**Fourth Addendum to the
Transbay Terminal/Caltrain Downtown Extension/Redevelopment Project
Final Environmental Impact Statement/Environmental Impact Report
(SCH #95063004)**

SUMMARY DESCRIPTION OF FOURTH ADDENDUM

Figure 1, Revised Temporary Terminal Configuration and Off-site Traffic Circulation and Lane Configuration Plan

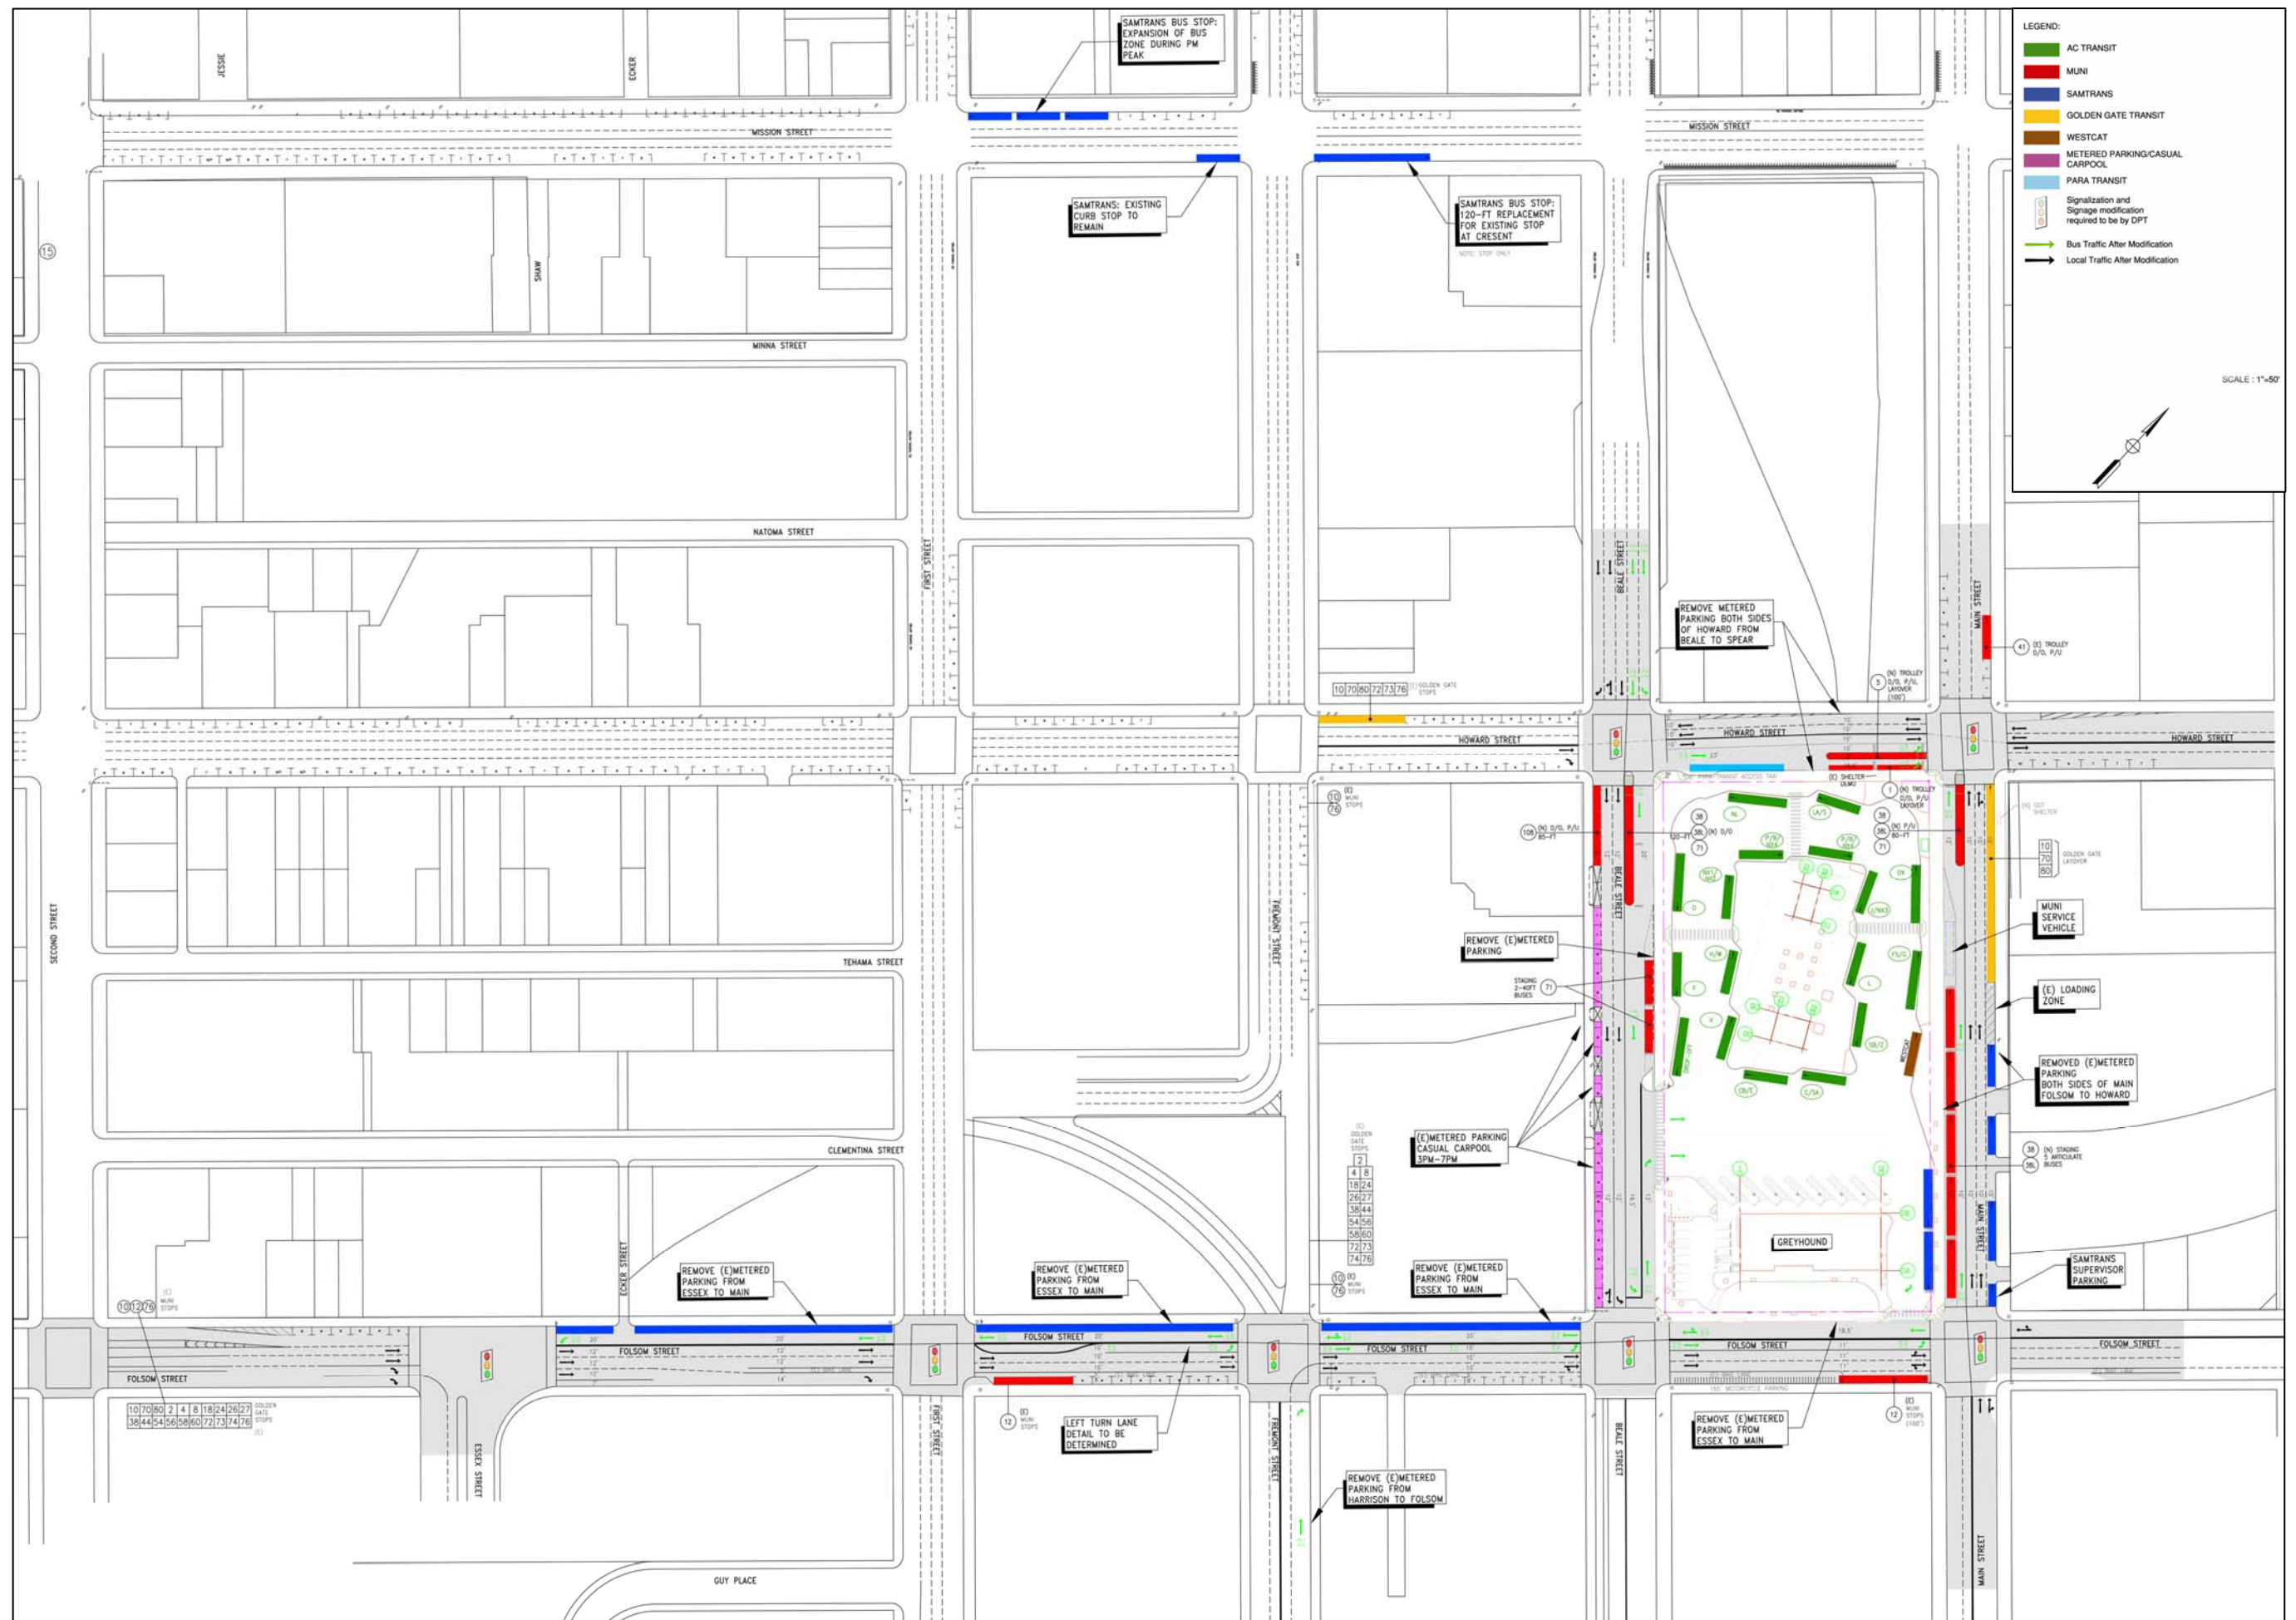
Although the purpose and function of the Temporary Terminal remains as stated in the FEIS/EIR, pursuant to the proposed project revisions, the configuration of the terminal, boarding platforms and waiting areas, bus staging areas, and street design has changed. Instead of being located on two adjacent blocks, the Revised Temporary Terminal will be confined to one block, bounded by Howard, Main, Folsom, and Beale streets. The Revised Temporary Terminal will contain AC Transit and Greyhound operations in separate operating areas and facilities (**Figure 1**).

The consolidated operation of buses onto one block requires the reconfiguration of the bus operating areas and circulation patterns described in the FEIS/EIR (pages 2-21 and 5-184). In the revised scenario, AC Transit uses a center boarding facility that contains a 1,030-square-foot office building and a 700-square-foot security office in a landscaped plaza in the northern portion of the block. The temporary structures, which would be demolished when the Temporary Terminal ceases operation, have shallow foundations and minimal (14-foot) heights. The AC Transit area contains 18 bus bays, 17 designated for AC Transit and 1 for WestCAT. The bus bays are sheltered by overhead canopies. Appropriate signage, ticketing kiosks, transit information, bike racks, restrooms, and waste receptacles accompany the boarding areas. Newly established utility lines that serve the bus facilities connect with existing lines along and under the surrounding streets. A two-way circulation area for buses surrounds the center boarding facility. Three specially designated walkways connect the perimeter of the block with the center boarding facility. As indicated in the FEIS/EIR, all pedestrian access and passenger facilities meet the requirements of the Americans with Disabilities Act. Landscaping is included at key points along the block perimeter.

Access to the AC Transit and Greyhound boarding areas is provided mid-block along Beale Street (refer to **Figure 1**). All buses exit on Folsom Street on the east end of the block adjacent to a staging area for SamTrans buses. SamTrans also has staging areas along the north side of Folsom Street between Beale and Essex streets; these staging areas are shared with the Caltrans bike shuttle.

Boarding areas on the curbside of the surrounding blocks have also been modified from those described in the FEIS/EIR (page 2-21). In the revised scenario, SamTrans and Golden Gate Transit have separate staging areas on the east side of Main Street (refer to **Figure 1**). They share a boarding area, including a passenger shelter on the sidewalk, along Main near Howard Street. Across the street, Muni has a staging area and a boarding island that separates two lanes of northbound traffic from a bus lane on the west side of the street. Additional stops for Golden Gate Transit are located on the north side of Howard Street at Fremont Street and for Muni along Howard Street in front of the Temporary Terminal. Muni is also allotted stops along the east side of Main Street north of Howard Street and the west side of Beale Street, and a boarding island on Beale Street just south of Howard Street. Muni shares the west side of Beale Street with carpool pick-up. Paratransit services are designated along the south curb on Howard Street.

The proposed project revisions would add bus lanes on Howard Street (eastbound direction) and would modify bus lanes on Beale Street to allow travel in both southbound and northbound directions between Howard and Folsom streets. Immediately north of Howard Street, Beale Street is redesigned to accommodate two bus lanes on the east side of the street and one lane on the west side with traffic confined to the two center lanes. The reconfigured bus lanes facilitate bus turning movements onto Howard and circulation into the bus lane on Beale Street south of Howard Street.

As indicated in the FEIS/EIR (page 2-23), buses coming off the Bay Bridge use the Harrison Street off-ramp to access the Temporary Terminal via Fremont Street, Folsom Street, and the bus lane on the east side of Beale Street. Fremont Street south of Folsom Street includes a PM peak tow-away lane on the east side of the street to allow AC Transit bus staging. Additionally, Folsom Street has a left turn pocket for Golden Gate and SamTrans bus movements onto Fremont Street. For outbound buses traveling between the Temporary Terminal and the Bay Bridge, buses depart the terminal on Folsom Street and use the Folsom Street westbound bus lane to reach Essex Street. Along Essex Street, buses continue in the southbound bus lane to reach the Bay Bridge on-ramp (refer to **Figure 1**). Bus lanes operating against the flow of traffic on these streets are in designated contra-flow lanes.

Additional modifications in the revised scenario include a PM peak bus staging area for AC Transit in one eastbound lane of Folsom Street between Fremont and Beale streets, and signal modifications along Folsom Street at First, Fremont, Beale, and Main streets and along Howard at Beale and Main streets to facilitate bus movement. **Table 1** compares the street and bus travel lane modifications for the Temporary Terminal described in the FEIS/EIR with those in the revised scenario.
